Ref: AFS-14-0105

SUBJECT: BRR Package Amendment Request, Docket No. 71-9341, SAR Revision 7

BEA Research Reactor Package

**Revision 7
March 2014**

Figure 3.3-9 – Bounding Transient Heat Up During Vacuum Drying

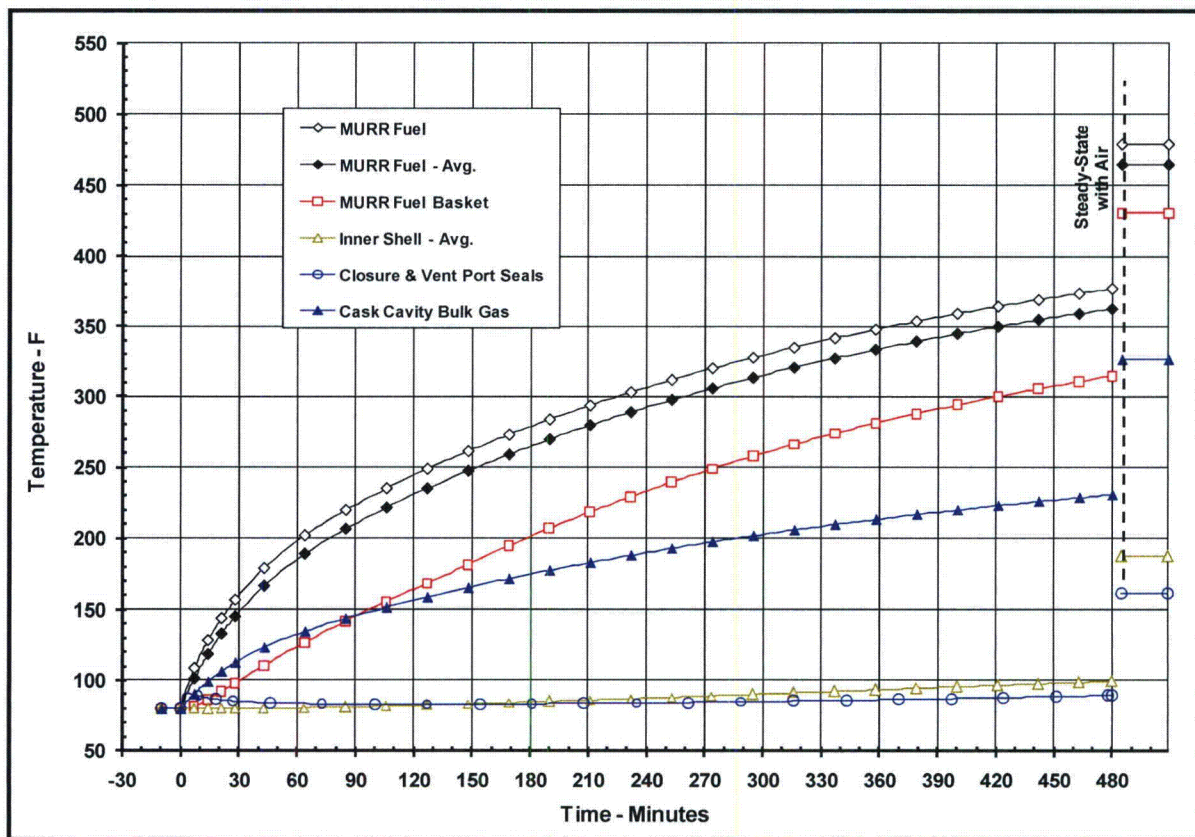
Figure 3.3-9 illustrates the predicted package heat up following removal from the fuel pool. The illustrated thermal transient shows that approximately 10 hours is required (based on extrapolation of the transient trend) before the peak fuel plate temperature reaches 400°F. The computed peak fuel plate temperature under steady-state conditions of 480°F will require a total of approximately 17 hours to achieve. Table 3.3-5 provides a listing of the peak temperatures achieved by the cask and payload components for steady-state conditions. Since the peak fuel plate temperature of 480°F is well below the 932°F limit established in Section 3.2.2, *Technical Specifications of Components*, for this condition, indefinite operation under either air (or nitrogen gas) filled conditions or vacuum drying is permissible for in-facility operations.

Figure 3.3-10 – Bounding Transient Cool Down Following Helium Backfill

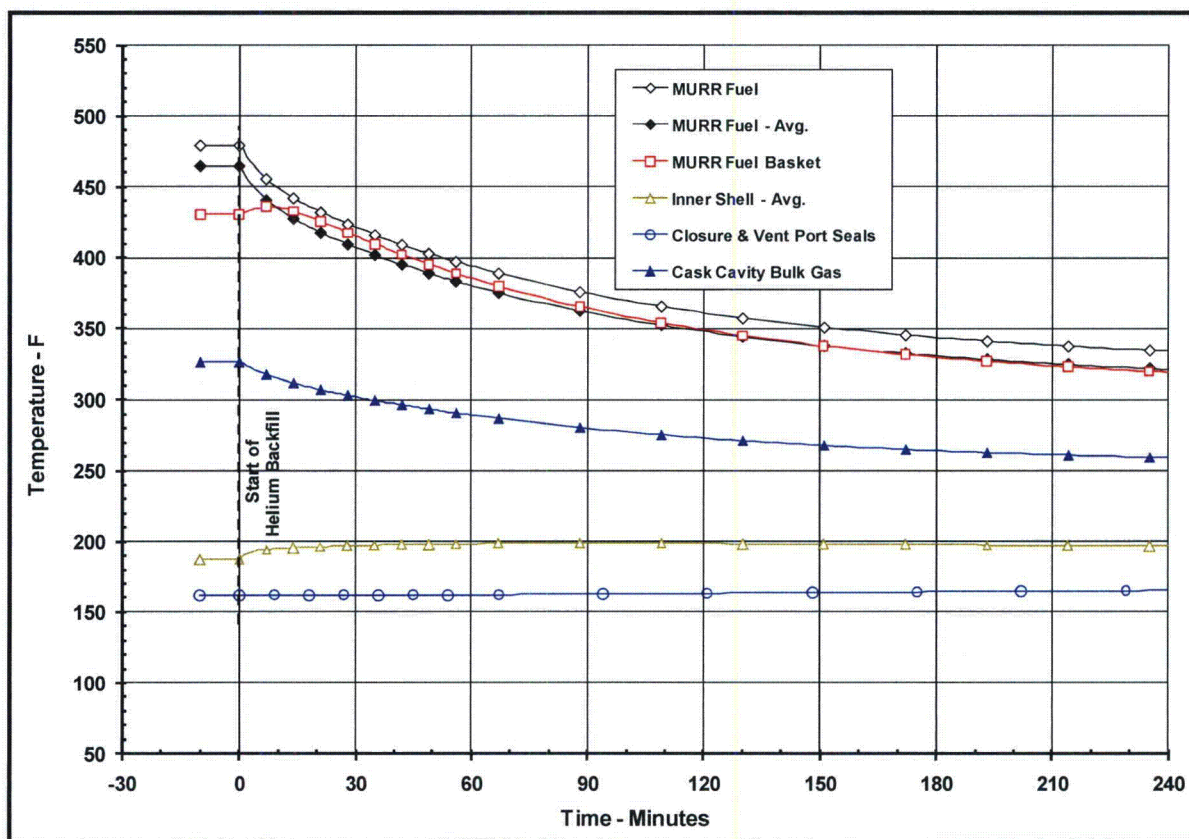
Figure 3.3-10 illustrates the cool down transient after helium backfill assuming an initial temperature distribution of steady-state operations with an air or nitrogen atmosphere in the cask cavity. As seen from the figure, less than one hour is required to lower the peak fuel plate temperature to below 400°F. Approximately three hours are required to lower the fuel and cask component temperatures to those reported in Section 3.3.1.1, *Maximum Temperatures*, for the *NCT Hot* condition. Given that final leak testing and cask closure will take much longer than three hours, the temperature of the package and payload will be at or near those computed for the *NCT Hot without Solar* condition well before transport begins. Thus, no changes to the thermal or structural analyses for transport are necessary as a result of the elevated fuel cladding temperature potentially achieved under vacuum drying operations.
